APPENDIX A

CEDAR VIEWS APARTMENTS – RETROFIT PLAN

PLANNED RETROFITS¹

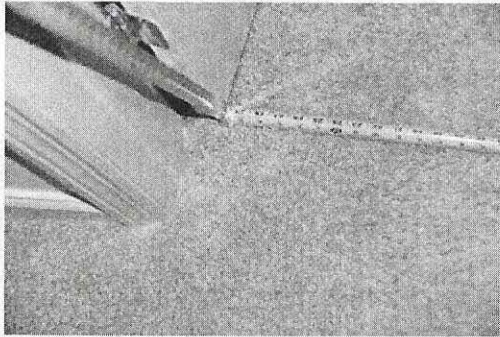
Inaccessible Feature	Photograph(s)	Retrofit(s)
<p>D.22. In the master bathroom, the toilet centerline is 14 1/2" from the sidewall.</p> <p>Toilet centerline must be at least 18" from the sidewall or bathtub.</p> <p>(FHA Guidelines Req. 7(2)(a)(ii) or 7(2)(b)(iv))</p> <p>(Note: This issue was observed in Unit 17 but not in Unit 211.)</p>	 <p>(DSC01058.jpg – Unit 17)</p>	<p>Retrofit toilets that have either of the following inaccessible features on the far side of the fixture:</p> <ul style="list-style-type: none"> c. Toilet centerlines that are less than 17" from an adjacent tub, shower, or wall surface that is less than 28" in length; or d. Toilet centerlines that are less than 15 1/2" from an adjacent side wall that is minimum 28" long. <p>Relocate toilet to position required by the safe harbor.</p> <p>Exception 1: where a toilet is less than 15-1/2" from an adjacent tub, shower, or wall surface located on the far side of the toilet and there is no 28" sidewall, relocate the toilet as far as possible towards the direction of approach using an offset flange. Document centerline conditions before and after relocation. Provide list of toilets affected by this exception and their centerline dimensions before and after relocation to the DOJ and the neutral inspector prior to the inspection.</p>

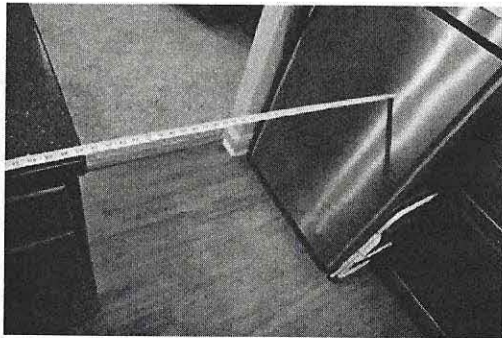
Inaccessible Feature	Photograph(s)	Retrofit(s)
D.24.	<p>The door to the powder room has a clear opening of 27 5/8". The laundry equipment is in this room.</p> <p>Door clear opening must be at least 31 5/8".</p> <p>(FHA Guidelines Req. 3(2))</p> <p>(Note: This issue was observed in Unit 326 but not in Unit 124.)</p>	No photograph taken.	Replace and reframe door to provide at least 31 5/8" clear opening.
D.25.	<p>The kitchen sink is located in a corner and has a base cabinet. The parallel clear floor space is about 16 1/2" wide.</p> <p>Clear floor space at the kitchen sink must be at least 30" by 48" and centered.</p> <p>(FHA Guidelines Req. 7(1)(a))</p>	 <p>(DSC01176.jpg – Unit 124)</p>	Design the reconfiguration of the kitchen to provide a compliant parallel or forward approach and submit the design to DOJ for review and approval. Include removable sink base if forward approach is used. Renovate the kitchens consistent with the approved design, including necessary repair or replacement of finishes, flooring, and counter supports.

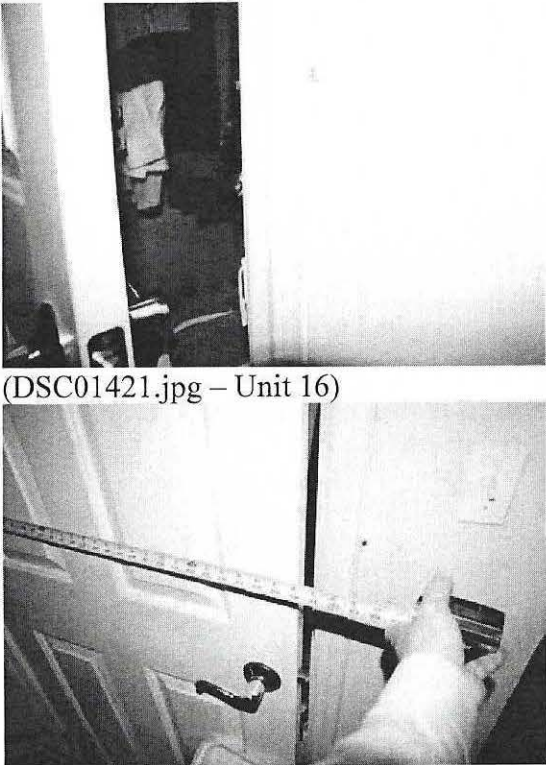
Inaccessible Feature	Photograph(s)	Retrofit(s)
<p>D.29. The parallel clear floor space for the lavatory is off-center by 6" in Unit 222 and 5 1/2" in Unit 422. A forward approach is blocked by a vanity.</p> <p>Clear floor space for the lavatory must be at least 30" by 48". It must be centered. If forward, knee and toe space must be provided under the lavatory.</p> <p>(FHA Guidelines Req. 7(2)(a)(ii) or 7(2)(b)(v))</p>	 <p>(DSC01325.jpg – Unit 222)</p>  <p>(DSC01285.jpg – Unit 422)</p>	<p>Relocate lavatory or replace vanity with unit that has a removable cabinet.</p>

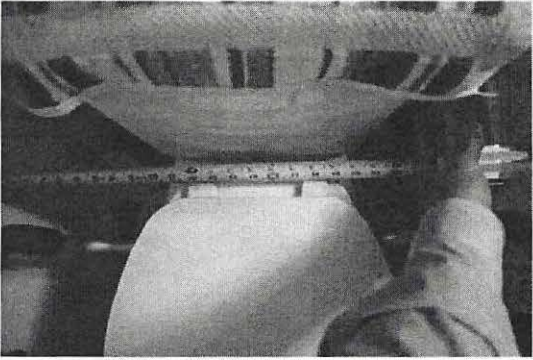
Inaccessible Feature	Photograph(s)	Retrofit(s)
<p>D.34. The parallel clear floor space for the lavatory in Unit 221 is about 40" long and is off-center by 12". The parallel clear floor space for the lavatory in Unit 319 is about 41 3/4" long and is off-center by 11 1/2". In both units, a forward approach is blocked by the vanity.</p> <p>Clear floor space for the lavatory must be at least 30" by 48". It must be centered. If forward, knee and toe space must be provided under the lavatory.</p> <p>(FHA Guidelines Req. 7(2)(a)(ii) or 7(2)(b)(v))</p>	 <p>(DSC01300.jpg – Unit 221)</p>  <p>(DSC01229.jpg – Unit 319)</p>	<p>Relocate lavatory or replace vanity with unit that has a removable cabinet.</p>

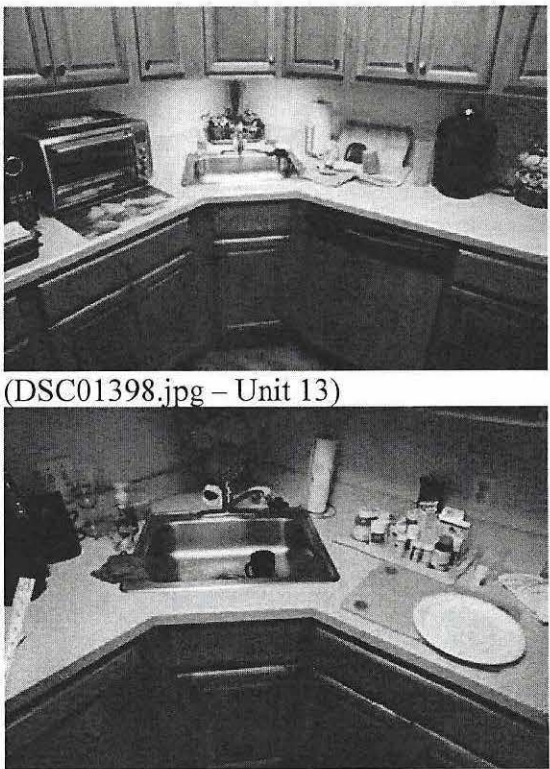
Inaccessible Feature	Photograph(s)	Retrofit(s)
D.38.	<p>The parallel clear floor space for the lavatory is off-center by 8 1/4" in Unit 16. A forward approach is blocked by a vanity.</p> <p>Clear floor space for the lavatory must be at least 30" by 48". It must be centered. If forward, knee and toe space must be provided under the lavatory.</p> <p>(FHA Guidelines Req. 7(2)(a)(ii) or 7(2)(b)(v))</p> <p>(Note: This issue was observed in Unit 16 but not in Unit 18.)</p>	 <p>(DSC01412.jpg – Unit 222)</p>	<p>Relocate lavatory or replace vanity with unit that has a removable cabinet.</p>
